**From:** Clive Russell  
**Sent:** 19/10/2023 11:08:39 AM  
**To:** Council Northernbeaches Mailbox  
**Subject:** TRIMMED Submission query re DA2023/1428  
**Attachments:** DA Queries 18 Oct 2023.pdf;

Thank you for taking time to review the below (& attached) concerns and queries pertaining to Application number DA2023/1428 located at 14 Kristine Place, MONA VALE.

**FIG 1**

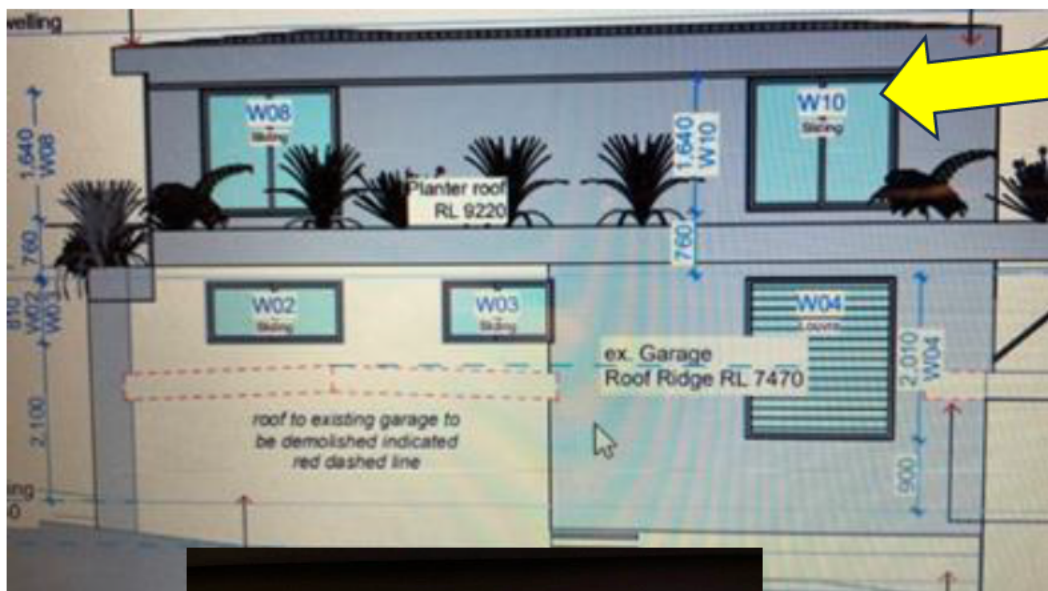
1. Window on upper level and highlighted in the attached "FIG 1". I was of the understanding that the window was going to be "narrow & high". The window here does not appear to be narrow, high, opaque or have shutters and as such could potentially have an unacceptable impact of the visual privacy overlooking private areas including the backyard entertaining areas and where my children play as well as overlooking into my main bedroom.

Window here **does not** appear to be narrow, high, opaque or have shutters & as such could potentially have an unacceptable impact on the visual privacy overlooking private areas including backyard where my children play & also overlooking the main bedroom.  
**REQUEST** – to review the size/shape/location/style of window.

**REQUEST** - to review the size, shape, location and style of the window to ensure there is no unacceptable impact on visual privacy to the areas mentioned.

**FIG 2**

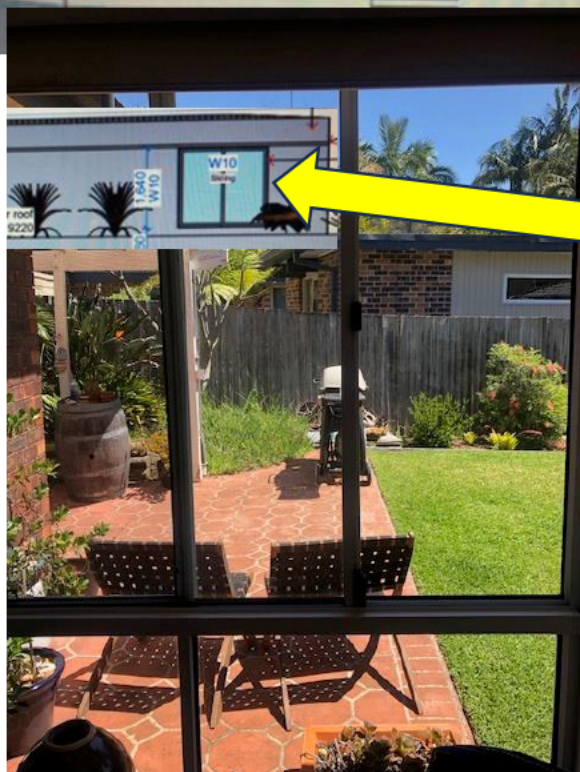
FIG 2 shows the view from my main bedroom from the inside looking outside and the likely location of the abovementioned window.

This is the view from my main bedroom window looking from the inside to the outside and likely where the window mentioned will be located and as such appears to be overlooking into private areas such as main bedroom & outdoor entertaining areas.

**FIG 3**

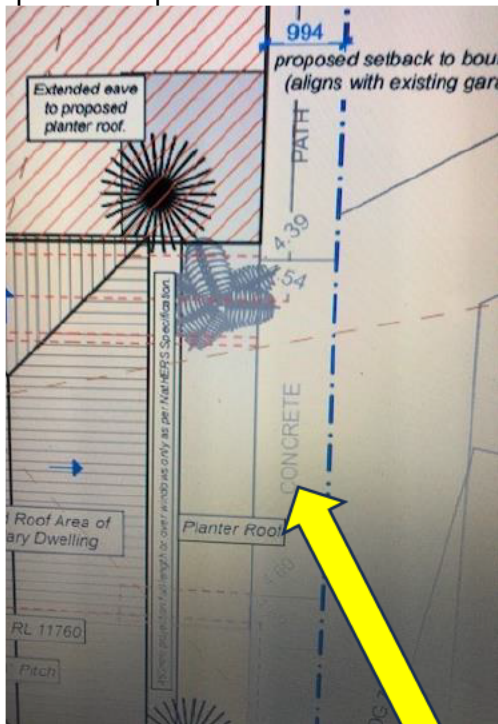
FIG 3 shows another angle whereby the window mentioned could have an unacceptable impact on the visual privacy overlooking private areas including backyard entertaining areas and where my children play.

Possible window location

Another angle whereby the window mentioned in FIG 1 could have an unacceptable impact on the visual privacy overlooking private areas including backyard entertaining areas and where my children play.
